## **FINAL NOTICE**

**DATE: MARCH 11, 2016**  
**TO: BLUE BIRD OWNERS**  
**SUBJECT: RECALL R15YD**  
**C E WHITE CUSHION FOAM NON-COMPLIANCE FMVSS 302**

**IMPORTANT SAFETY RECALL NOTICE**

**Subject: Recall R15YD, C E White – Cushion Foam Non-Compliance FMVSS 302  
Flammability of Interior Materials**

Photo # 1

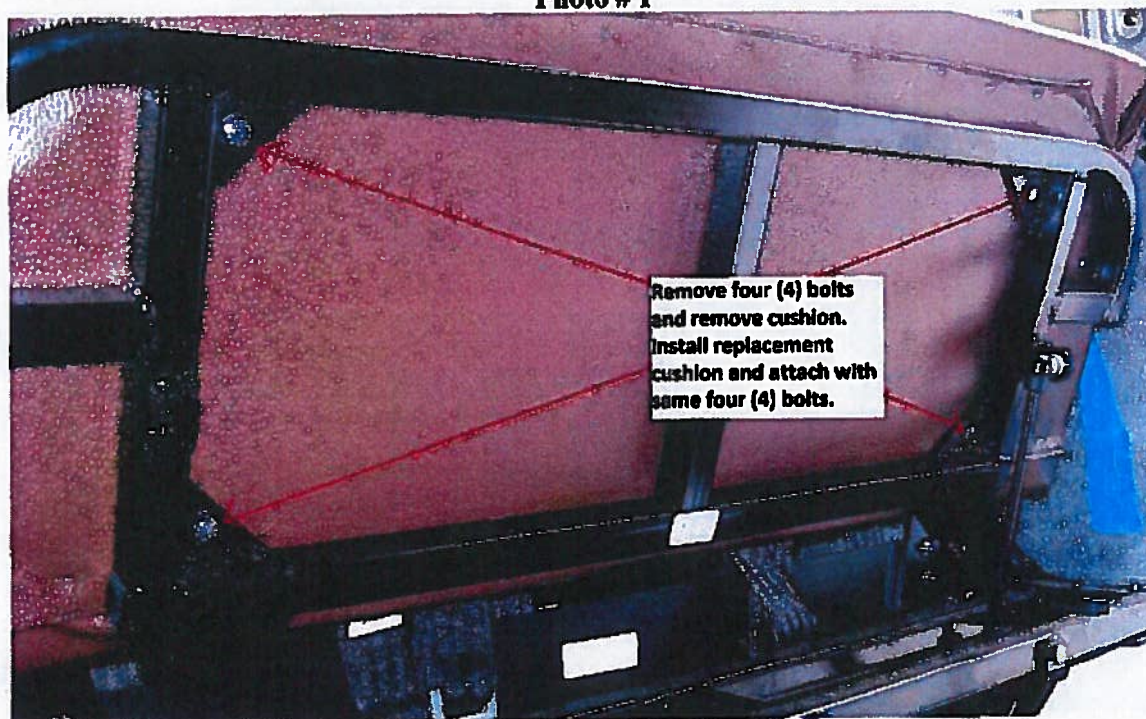
1. From bottom side of cushion, per Photo # 1 remove the four (4) bolts attaching cushion to flip seat frame.
2. Remove existing cushion and install replacement cushion with same four (4) bolts removed from original cushion.

Photo # 2

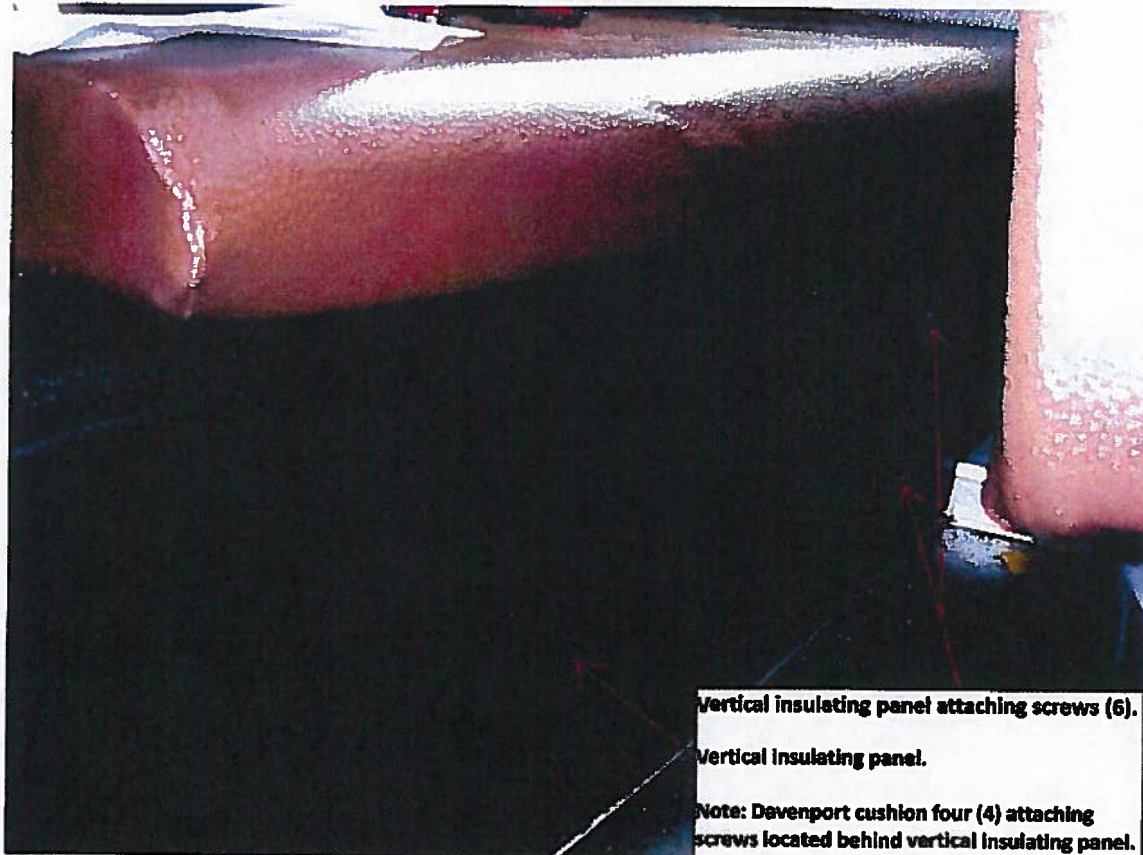
1. Remove trim caps to access six (6) screws attaching Davenport vertical insulating panel. Remove six (6) screws, pull insulating panel away from Davenport to access the four (4) screws per Davenport seat cushion (see Photo # 2).
2. Remove the four (4) Davenport seat cushion attaching screws, lift up and remove cushion assembly.
3. With cushion removed, using original cushions as location pattern, transfer the four (4) cushion attaching brackets from original cushion to replacement cushion (see Photo # 3).
4. Reinstall both right and left Davenport cushions and vertical insulating panel.
5. Repair complete.
